Access Compliance Report

Public Rights-of-Way

(Curb Ramps)

Intersection ID: 53894	Main Street: INVERNESS_BAY_RD	Cross Street: PERTH_MOOR_RD	Location: NE
ADA ID: 617E4A31F835	Ramp Type: Perp	Initial Pass/Fail: Fail	Overall Compliance: No
			Severity Score: 21.25

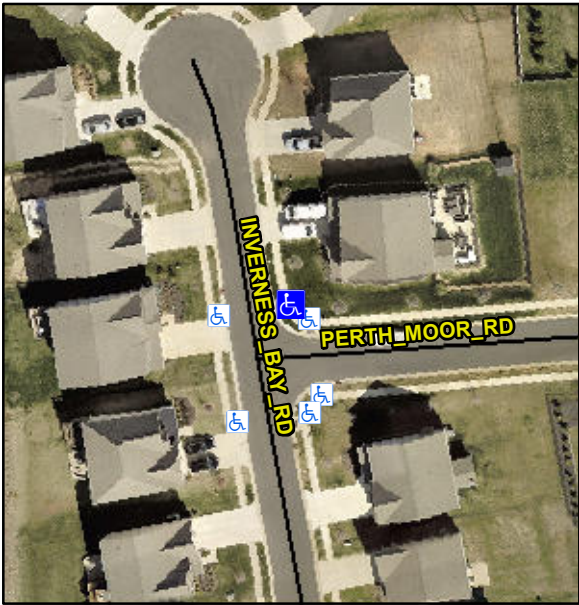
Codes/Mitigation Info/Possible Solution			Field Measurements/Component Compliance					
	Possible Solutions:		Compliance	Description	Data	Compliance	Description	Data
	Remove & Replace Entire Ramp.		N/A	Ramp Length (in)	51.0	No	Ramp Slope (%)	9.2
			No	Ramp Width (in)	46.5	Yes	Ramp XSlope (%)	0.5
			N/A	Flare Type LT	N/A	N/A	Flare Type RT	N/A
			N/A	Flare Slope LT (%)	N/A	N/A	Flare Slope RT (%)	N/A
			N/A	Flare Traversable LT?	N/A	N/A	Flare Traversable RT?	N/A
			N/A	Landing Length (in)	N/A	N/A	DWS Provided?	N/A
			N/A	Landing Width (in)	N/A	N/A	DWS Contrast?	N/A
			N/A	Landing Slope (%)	N/A	N/A	DWS Length (in)	N/A
			N/A	Landing X Slope (%)	N/A	N/A	DWS Full Width?	N/A
Surveyor Notes:	N/A		N/A	Landing Curb? (Y/N)	N/A	N/A	DWS Offset (in)	N/A
			N/A	Shared Landing?	N/A			
	PROW/ADA:		N/A	Gutter Ponding?	N/A	N/A	Gutter Slope (%)	N/A
	Not Found, R304.5.1, R304.2.2		N/A	Gutter Lip Ht (in)	1.0	N/A	Gutter X Slope (%)	N/A
